Application No.:10/782,574

Docket No.: JCLA12196

REMARKS**Present Status of the Application**

FIG. 4 (PRIOR ART)

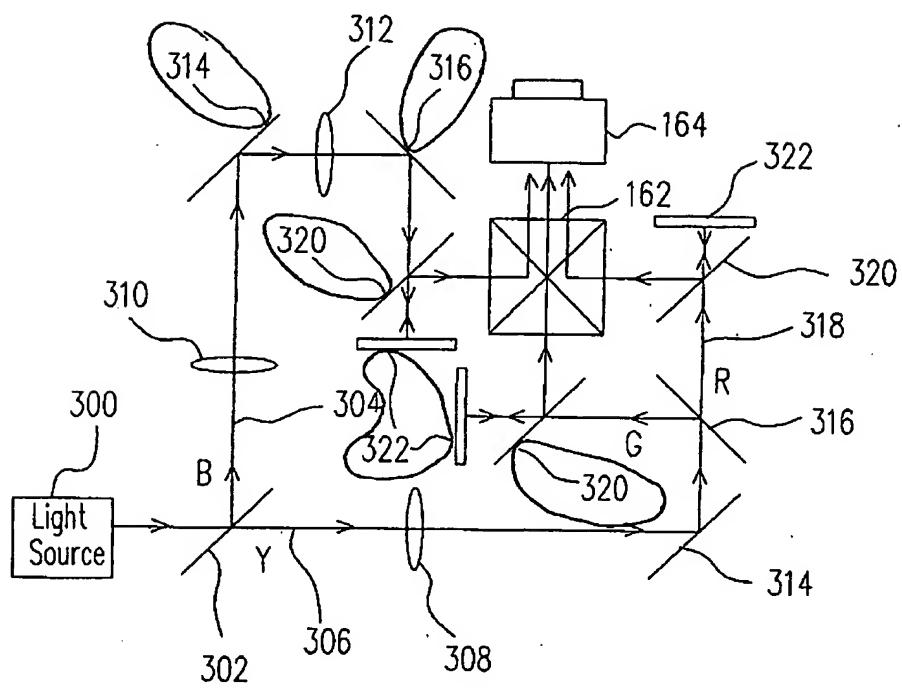
Please amend Figures 4, 7, 9, 10 and 11 as shown in red ink in the separate accompanying pages. Proposed corrected drawing including corrected Figures 4, 7, 9, 10 and 11 is also attached hereto in separate accompanying pages. Reconsideration is respectfully requested.

FIG. 7

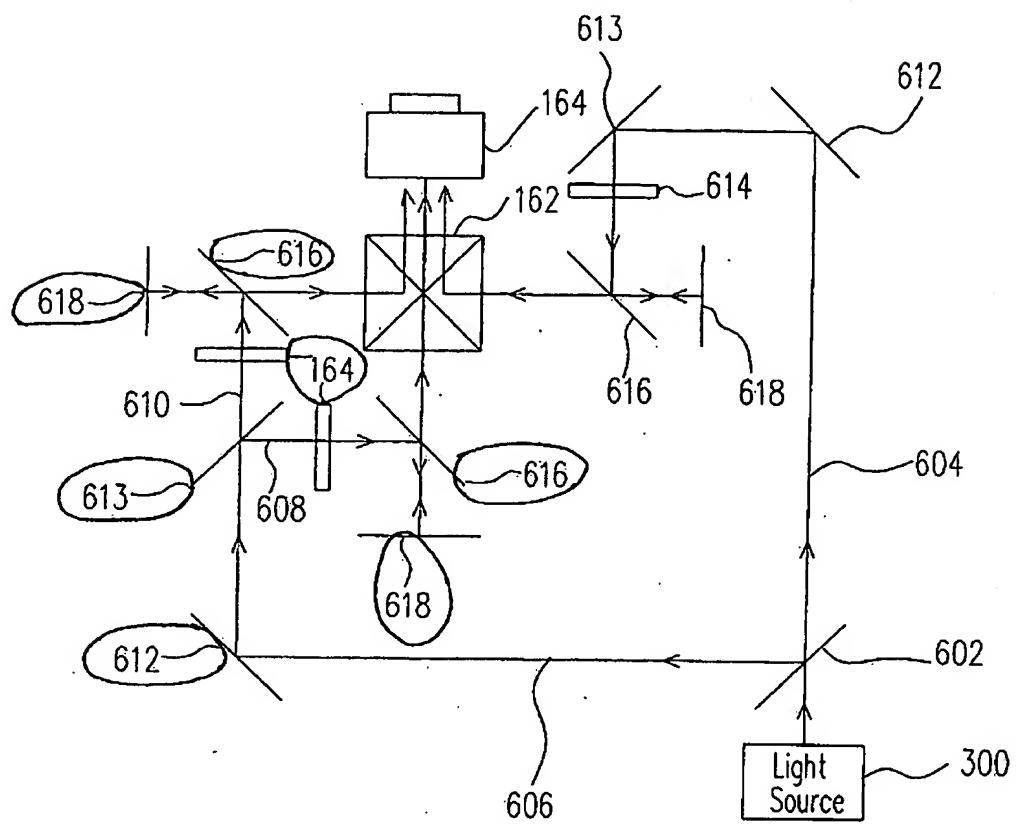
The Office Action objected to the drawings under 37 CFR 1.121(d) because Figure 7, for example, only one of the three wire grid polarizers and one of the liquid crystal panels, element number 616 and 618 respectively, are labeled and requests for labeling the remaining two of the three wire grid polarizer and the liquid crystal panels.

In response thereto, Applicants would like to thank the Examiner for pointing out the informalities and accordingly corrected the drawings as above. Reconsideration is respectfully requested.

FIG. 12

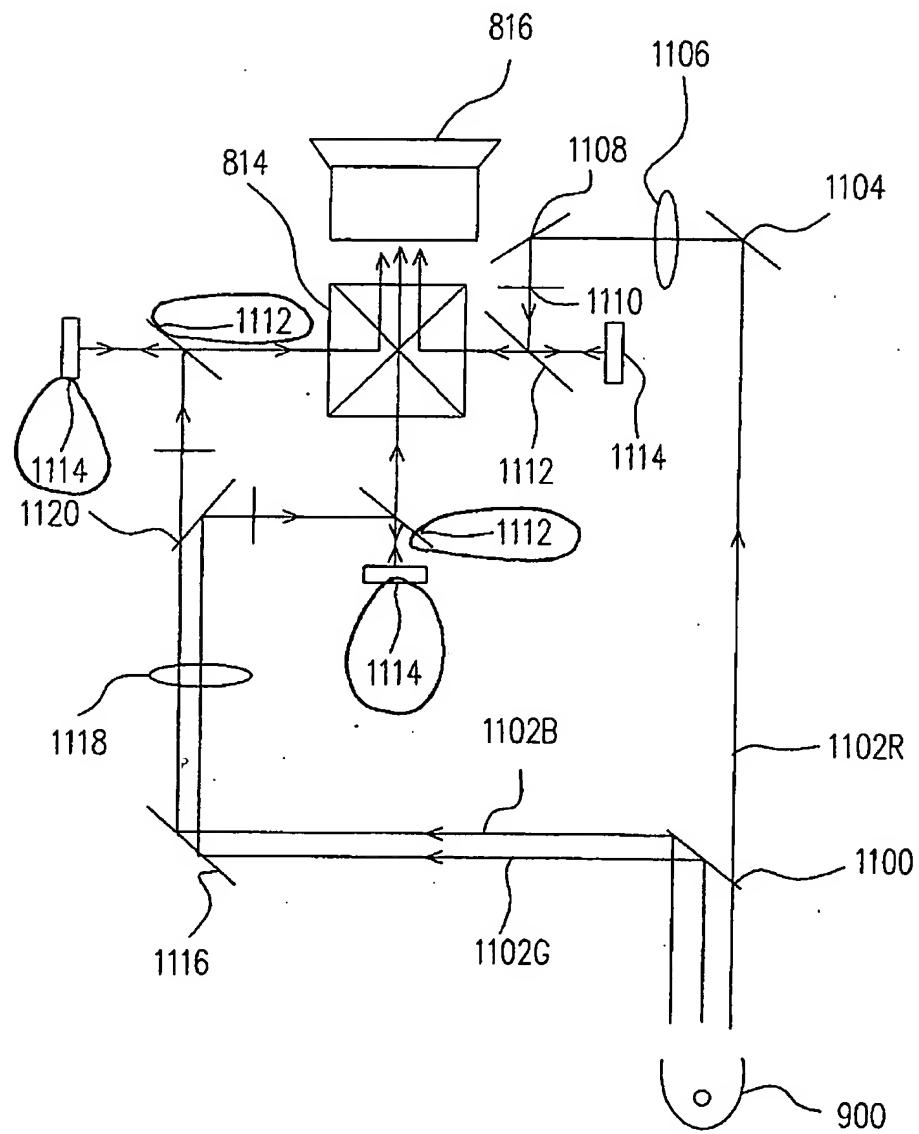
FIG. 4, 7 and 9-12 have been amended to overcome the Examiner's objections as set forth on page 2 of the outstanding Office Action. Proposed corrected FIG. 4, 7 and 9-12 are attached hereto as separate accompanying pages. Reconsideration is respectfully requested.
